# Access Compliance Report

## Public Rights-of-Way

Intersection ID: 50326	Main Street: THOREAU_CT	Cross Street: SHARPES_CR	Location: SE
ADA ID: B0319DC61FA8	Ramp Type: PerpDiag	Initial Pass/Fail: Fail	Overall Compliance: No
Severity Score: 10			
Codes/Mitigation Info/Possible Solution		Field Measurements/Component Compliance

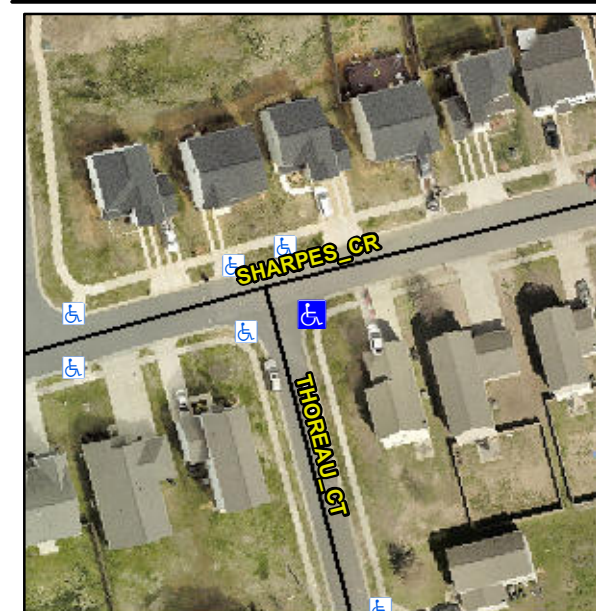
**Not Found, R304.5.1, R304.5.3**

Compliance	Description	Data	Compliance	Description	Data
N/A	Ramp Length (in)	46.0	Yes	Ramp Slope (%)	6.0
No	Ramp Width (in)	47.5	No	Ramp XSlope (%)	2.5
N/A	Flare Type LT	N/A	N/A	Flare Type RT	N/A
N/A	Flare Slope LT (%)	N/A	N/A	Flare Slope RT (%)	N/A
N/A	Flare Traversable LT?	N/A	N/A	Flare Traversable RT?	N/A
N/A	Landing Length (in)	N/A	N/A	DWS Provided?	N/A
N/A	Landing Width (in)	N/A	N/A	DWS Contrast?	N/A
N/A	Landing Slope (%)	N/A	N/A	DWS Length (in)	N/A
N/A	Landing X Slope (%)	N/A	N/A	DWS Full Width?	N/A
N/A	Landing Curb? (Y/N)	N/A	N/A	DWS Offset (in)	N/A
N/A	Shared Landing?	N/A			
N/A	Gutter Ponding?	N/A	N/A	Gutter Slope (%)	N/A
N/A	Gutter Lip Ht (in)	N/A	N/A	Gutter X Slope (%)	N/A
N/A	Painted X Walk1?	No	N/A	Painted X Walk2?	No
	X Walk 1 Direction	To N		X Walk 2 Direction	To W
N/A	X Walk 1 Width (in)	N/A	N/A	X Walk 2 Width (in)	N/A
	X Walk 1 Slope (%)	6.5		X Walk 2 Slope (%)	2.5
	X Walk 1 X Slope (%)	1.3		X Walk 2 X Slope (%)	5.2

**Remove & Replace Curb Ramp With Two New Directional Ramps or Equivalent.**
